ARBORICULTURAL REPORT

Summary Report for Cumberland Council

Reference: 4/24/2104/001

Location: RHEDA CROSS, RHEDA PARK, FRIZINGTON

Screenshot from the Westwood Landscape Tree Mitigation Plan - WW/L01 Rev.C (dated 24/03/25)

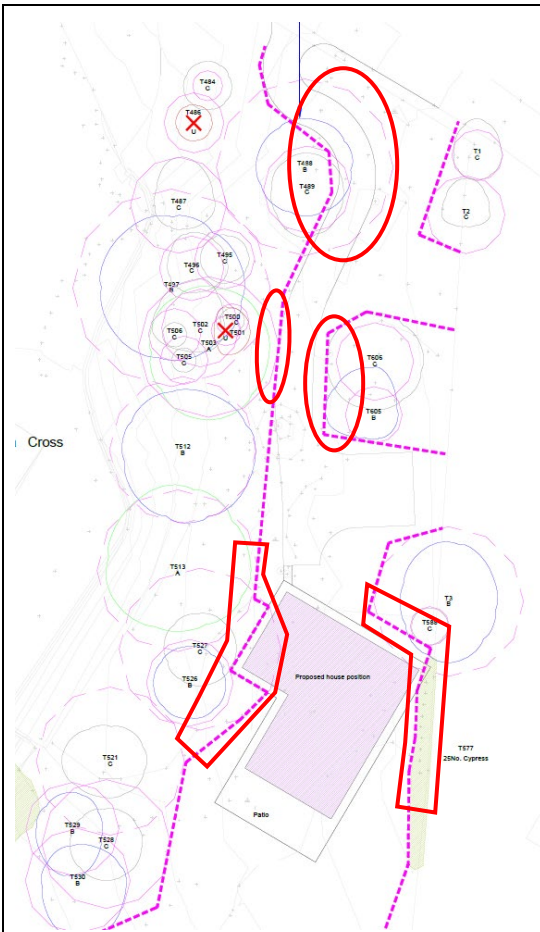
The Tree Mitigation Plan shows several areas where the proposed layout or construction operations are likely to impact on the trees and/or their root protection areas (RPAs). We have outlined these areas in red.

Construction Zone

The plan shows a line of the protective fencing (magenta dashed line) which appears to have been drawn arbitrarily to avoid the trees, their RPAs and the proposed scheme layout. The proposed protective fencing line does not appear to allow for construction traffic movements around the outside of the building or scaffolding around the building to allow construction. The protective fencing locations need to be practical, otherwise it is likely to result in loss of retained trees.

We suggest using a minimum of a 2m offset from the building footprint for scaffolding. In addition, in order to access the southern part of the proposed building, machinery is likely to require a further 3m offset for machinery and materials access. Along the driveway, we suggest a 1m offset either side to provide sufficient space to adequately construct the driveway.
